QUALITY ASSURANCE -- NON-CONFORMANCE REPORT

Location: Changxing Island, Shanghai, P.R. China**Report No:** NCR-000773**Prime Contractor:** American Bridge/Fluor Enterprises, a JV**Date:** 22-Jun-2010**Submitting Contractor:** Zhenhua Port Machinery Company, Ltd (ZPMC), Changxing Island**NCR #:** ZPMC-0735**Type of problem:**

Reference Description: QA found an UT Indication after the contractor's had tested and accepted a weld on the Suspender Bracket for Segment 7EW

Subject: NCR No. ZPMC-0735

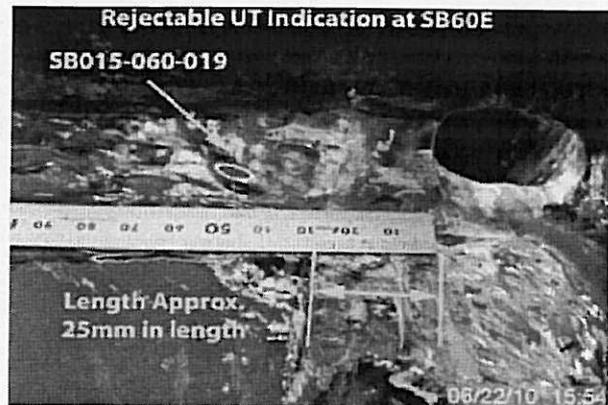
During the Quality Assurance (QA) Ultrasonic Testing (UT) review of welds located on Orthotropic Box Girder (OBG) Suspender Bracket SB60E, this QA Inspector discovered the following issues:

- One (1) class "A" rejectable longitudinal linear indication measuring approximately 25mm in length.
- The indication dBs rating is a +4.
- Material thickness is 20mm.
- The depth of the indication is approximately 14mm.
- The weld is identified as SB015-060-019 (Segment 7EW).
- The weld is Complete Joint Penetration (CJP) "T" joint.
- The weld is joining between X53A to X53B.
- The weld is designated as a Non Seismic Performance Critical Material (Non SPCM).
- The indication is clearly marked on or near the weld.
- The Y distance for this indication is 5 mm from cope hole.
- Suspender Bracket SB60E is located at Bay#19.

The Notice of Witness Inspection (NWIT) No. is 006035. The indication is located within the area previously tested and accepted by ZPMC Quality Control (QC) personnel. As per the contract documents, ZPMC's QC personnel are required to perform hundred (100%) percent UT inspection of this weld.

Repair said indication and perform NDT required to verify weld quality.

Contractor supplied post repair NDT documentation verifying weld conforms with Contract weld quality requirements. An internal NCR was also issued by ZPMC in regards to this issue.
